# UNITED STATES PATENT AND TRADEMARK OFFICE

APPLICATION NO.	FILING DATE	FIRST NAMED INVENTOR	ATTORNEY DOCKET NO.	CONFIRMATION NO.
10/608,467	06/25/2003	Gary K. Burma	H0003936 US	9362
128 7590 01/17/2008 HONEYWELL INTERNATIONAL INC. 101 COLUMBIA ROAD P O BOX 2245 MORRISTOWN, NJ 07962-2245			EXAMINER FORTUNA, JOSE A	
			ART UNIT 1791	PAPER NUMBER
			MAIL DATE 01/17/2008	DELIVERY MODE PAPER

## Office Action Summary

**Different fan sprays = different shape**

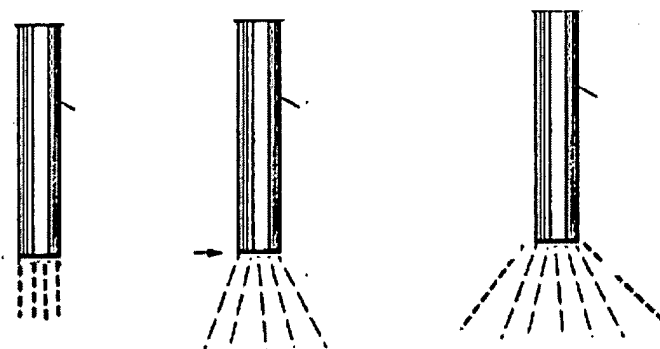
along a common line, i.e., controlling the shape of actuator response as claimed. Figure 1 shows also the use of scanners (16) downstream of the actuators. Delight teaches that the valves are controlled using three binary control to activate different capacity spray nozzles to achieve eight distinct flow rates over the full control range and each valve can be restricted to different flow rate, i.e., the magnitude and the shape of the actuator response, by controlling the amount of fluid through the selected valve, are controlled. Note that it would be obvious to one of ordinary skill in the art to individually control the shape and magnitude of each nozzle, based on the fact of new developments in the computer art, see below. Also the references teach that if a more accurate profile is desired the nozzles can be operated individually. Specifically Delight teaches that the each nozzle can be controlled to vary the magnitude and then the nozzles are adjusted to change the fan spray, see paragraph bridging columns 4 and 5. The fan spray changes reads in the change of shape, since changing the width of the spray changes the shape, see figure below.
